MCPB Item No. Date: 4/8/2021

Toll Brothers – Phase 2 Cabin Branch: Limited Major Site Plan Amendment No. 82010003A

Request to amend condition 21b to remove the fence requirement at the rear of lots 35 - 48 and lots 58 - 60 on Block AD and replace it with trees and landscaping within the green space along West Old Baltimore Road; 108.56 acres.

Figure 4 – Site Plan 82010003A

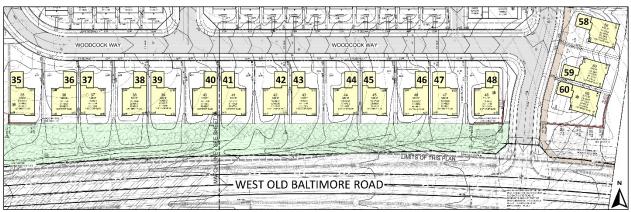
On December 2, 2020, the Applicant filed Site Plan No. 82010003A ("Application") proposing to remove the fence located at the rear of Lots 35 - 48 and Lots 58 - 60 and replace it with trees and landscaping along West Old Baltimore Road, while retaining the existing masonry site walls at Lots 35, 48, and 60.

Landscaping, consisting of a mix of evergreen and shade trees with understory shrubs, are being added at this location which previously had approved fencing. The landscaping helps to delineate the backyards and provide separation between the backyards and West Old Baltimore Road, while also maintaining a softer, more scenic character for the streetscape along West Old Baltimore Road. The addition of landscaping and trees along the slopes also greatly improves views from the backyards and the public realm along the street.

b. Block AD, Lots 35-48, Lots 58-60: Provide trees and landscaping uniform fencing for the rear yards for each of these lots visible from along West Old Baltimore Road; for the walls at the rear of Lots 35, 48, and 60 along West Old Baltimore, use stone materials, such as a stone base and columns, consistent with Cabin Branch monument signage;
